**Meridian Airport Authority, Dean Aircraft Services
Hangar Additions & Alterations**

ADDENDUM NO. 4

TO: All Bidders on the Above Referenced Product
FROM: Davis Purdy Architects, PLLC
DATE: April 5, 2021
SUBJECT: **ADDENDUM NO. 4**

①
E-201 POWER PLAN - HANGAR/SHOP - ALTERNATE #1
Scale: 1/8" = 1'-0"

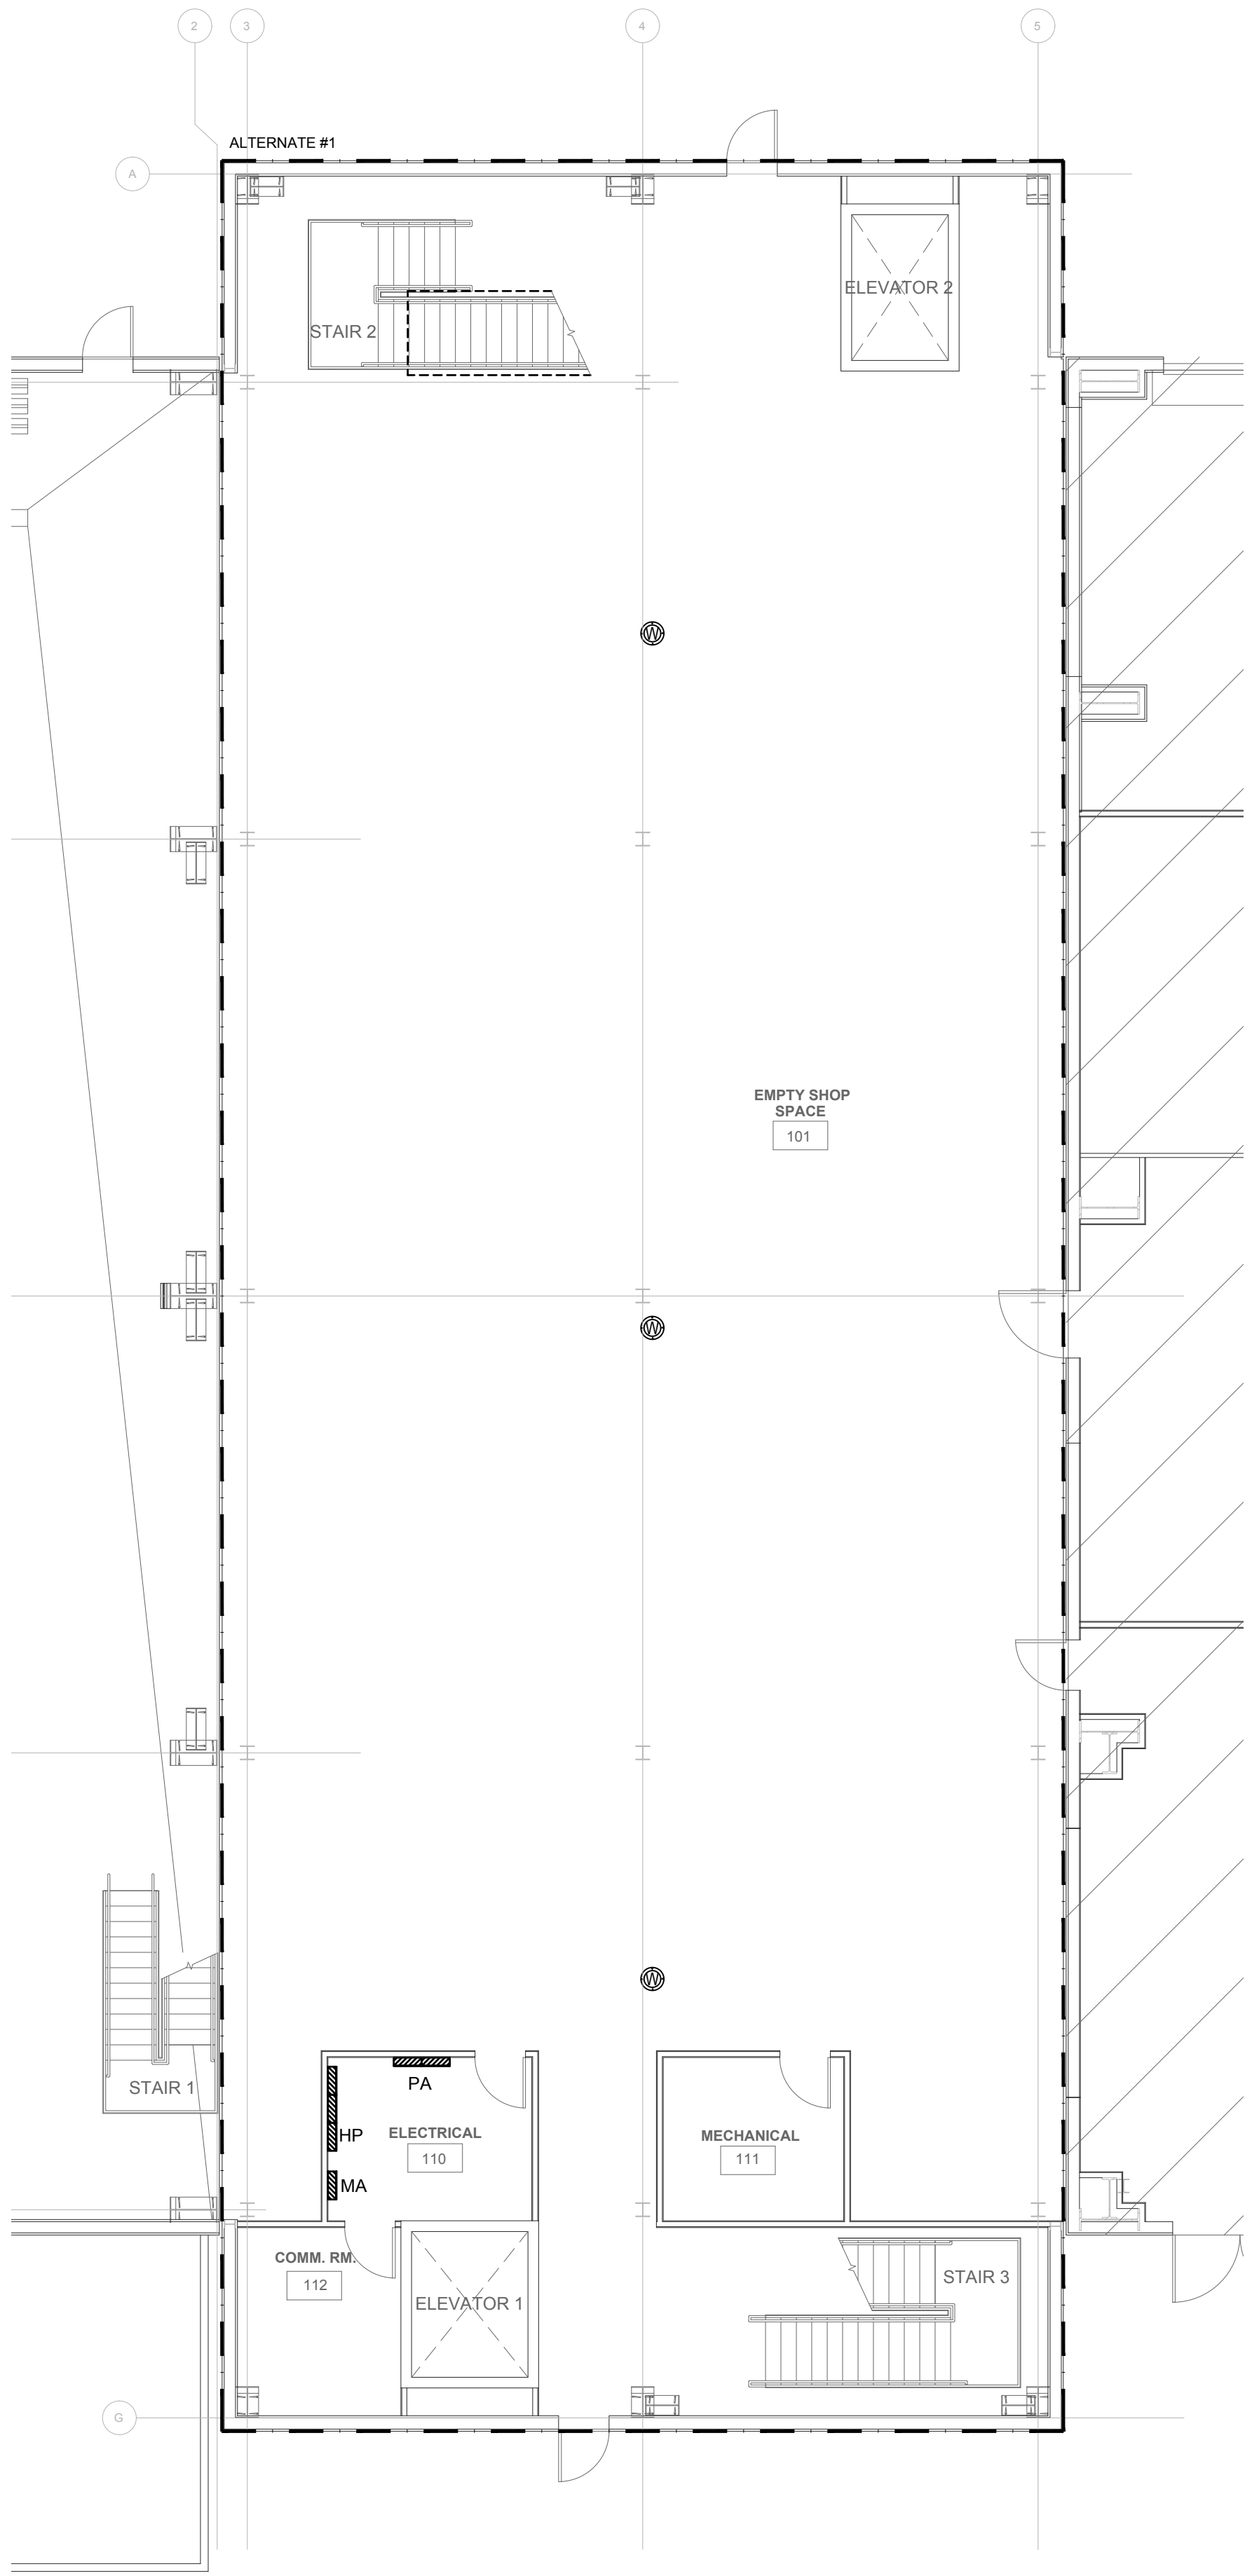
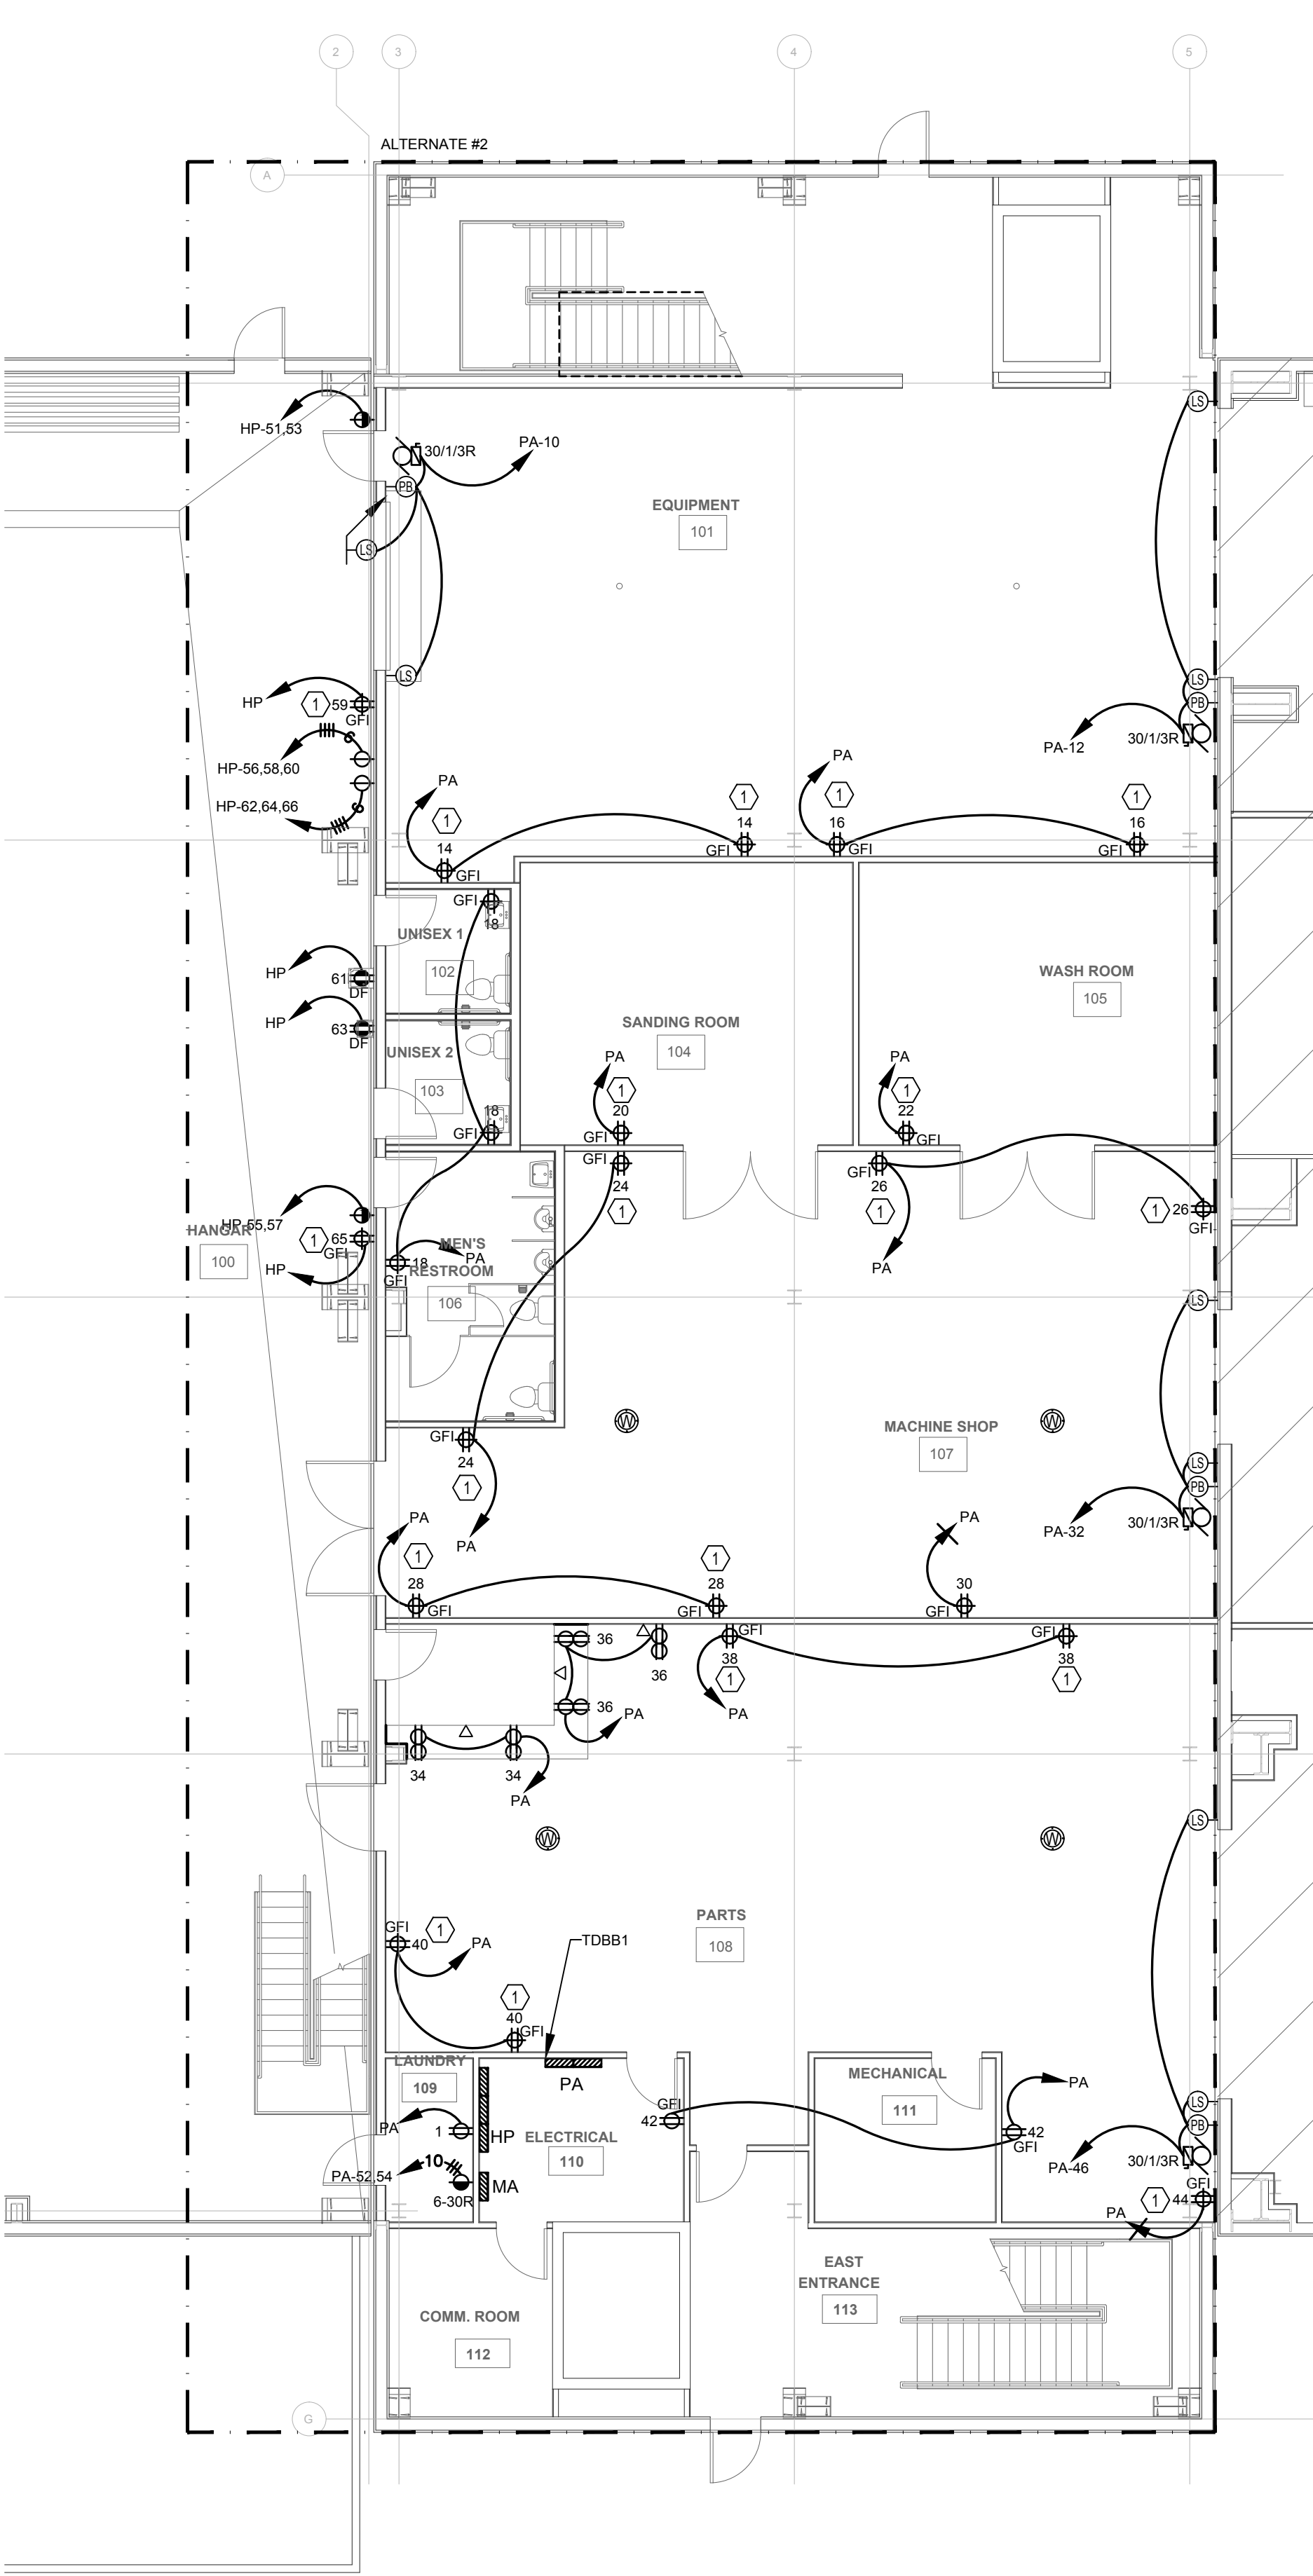
E-201 – Added Location of Existing TDBB
